Stage 03: Modification Report

National Electricity Transmission System Security
and Quality of Supply Standards (NETS SQSS)

GSR014: Review of Requirement of Onshore Connection Facilities for Offshore Wind Farm Connections

This Modification Report seeks to modify NETS SQSS Section 7.13.1.1: Onshore Connection Facilities: AC Circuits.

Figure 1. Schematic diagram of the offshore transmission system designs considered.

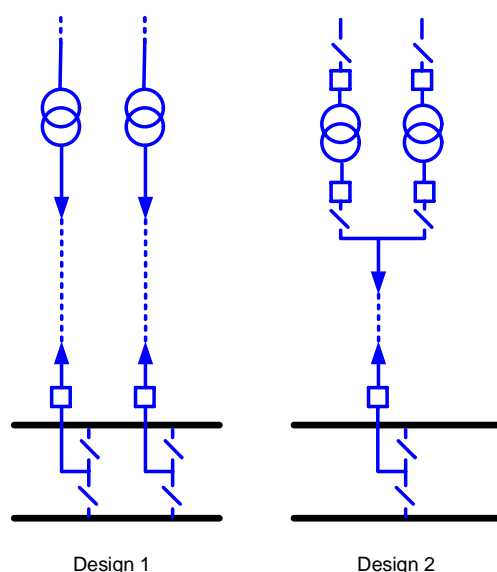
- 1.8 The Spackman approach was used to compare the costs and benefits between Design 1 and Design 2, both shown in Figure 1 above.
- The capital costs used were the transmission investment costs of each design. The transmission capital costs were converted into an annual cost using the IDC value of 7.9%. This produces a stream of financing costs or an appropriate time profile of annualised costs.

- 1.9 The results show that using the Spackman approach, Design 1 gives a higher NPV benefit compared to Design 2 when tested over a range of generation capacities for both AIS and GIS switchgear designs.

- (i) Several respondents stated that they would prefer that a standard requirement for 2 switch-bays was not included in the NETS SQSS. They would prefer a cost benefit assessment be carried out on each design.
- (ii) Several respondents were concerned as to whether the cost benefit analysis had been sufficiently broad. Additional cases were identified including generation entry capacities below 250MW, longer cable lengths and the connection to 275kV substations.
- (iii) One respondent was concerned as to whether other equipment such as reactive compensation should be factored into the assessment.

- (v) One respondent was concerned that the capital costs of a two switch-bay connection could be much higher than assumed in the analysis.
- (vi) One respondent suggested a potentially less expensive design option based on disconnectors.

- 4.19 The workgroup considered disconnector based solutions but did not pursue these as they would lead to greater curtailment of generation capacity. For GIS substations, the cost differential between disconnector only and circuit breaker based solutions is also likely to be small.

- 1.10 Based upon these results as presented in the Working-Group Report, and the additional sensitivities completed following the industry consultation, it is proposed that a number of changes are implemented to NETS SQSS Section 7.13.1.1. The legal text required to implement these proposals is provided within Annex 1 of this document. These changes would apply where there is AC transformation to the onshore transmission network and not where there are DC connection and conversion facilities. To further clarify this distinction between AC and DC connections, it is proposed to change the headings of Section 7.13.1 and Section 7.13.2 also. Again, these proposals are provided within Annex 1 of this document.

- 4.6 The workgroup assessment has demonstrated that where there are 2 transformers, it is economic to have 2 switch-bays except in exceptional circumstances. Making 2 switch-bays as the standard connection is clearer than the current position and does not preclude other connections if these are shown to be cost-beneficial. (However, if it was decided to bank 2 transformers onto a single switch-bay, this would require derogation.)

- 4.18 If the capital costs of a two switch-bay connection were particularly high compared to a single switch-bay connection, due to the need for major extension of an existing substation for example, this could be demonstrated through a cost benefit assessment and a design variation or derogation could be sought.
